Access Compliance Report

Public Rights-of-Way

Intersection ID: N/A	Main Street: HALKIRK_MANOR_LN	Cross Street: KIRKWYND_COMMONS_DR	Location: NE
ADA ID: 9B84A1794DDF	Ramp Type: PerpDiag	Initial Pass/Fail: Fail	Overall Compliance: No
Codes/Mitigation Info/Possible Solution		Field Measurements/Component Compliance

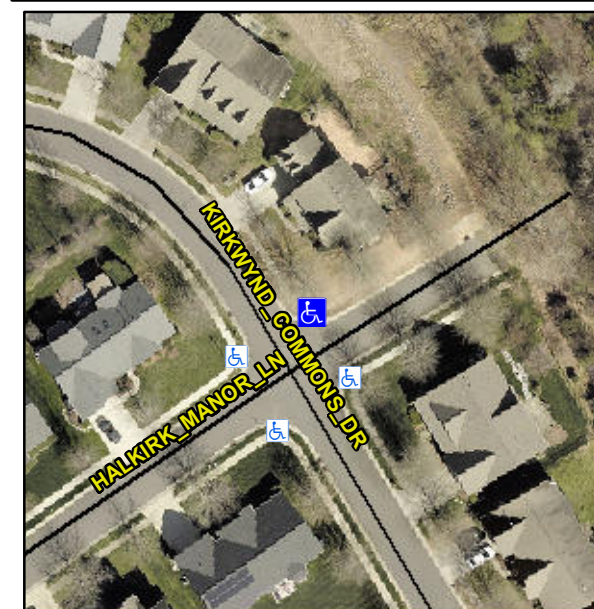
Not Found, R304.5.1

Compliance	Description	Data	Compliance	Description	Data
N/A	Ramp Length (in)	47.0	Yes	Ramp Slope (%)	5.7
No	Ramp Width (in)	46.0	Yes	Ramp XSlope (%)	2.2
N/A	Flare Type LT	N/A	N/A	Flare Type RT	N/A
N/A	Flare Slope LT (%)	N/A	N/A	Flare Slope RT (%)	N/A
N/A	Flare Traversable LT?	N/A	N/A	Flare Traversable RT?	N/A
N/A	Landing Length (in)	N/A	N/A	DWS Provided?	N/A
N/A	Landing Width (in)	N/A	N/A	DWS Contrast?	N/A
N/A	Landing Slope (%)	N/A	N/A	DWS Length (in)	N/A
N/A	Landing X Slope (%)	N/A	N/A	DWS Full Width?	N/A
N/A	Landing Curb? (Y/N)	N/A	N/A	DWS Offset (in)	N/A
N/A	Shared Landing?	N/A			
N/A	Gutter Ponding?	N/A	N/A	Gutter Slope (%)	N/A
N/A	Gutter Lip Ht (in)	N/A	N/A	Gutter X Slope (%)	N/A
N/A	Painted X Walk1?	No	N/A	Painted X Walk2?	No
	X Walk 1 Direction	To SW		X Walk 2 Direction	To SE
N/A	X Walk 1 Width (in)	N/A	N/A	X Walk 2 Width (in)	N/A
	X Walk 1 Slope (%)	7.3		X Walk 2 Slope (%)	4.9
	X Walk 1 X Slope (%)	1.4		X Walk 2 X Slope (%)	4.1

Remove & Replace Curb Ramp With Two New Directional Ramps or Equivalent.
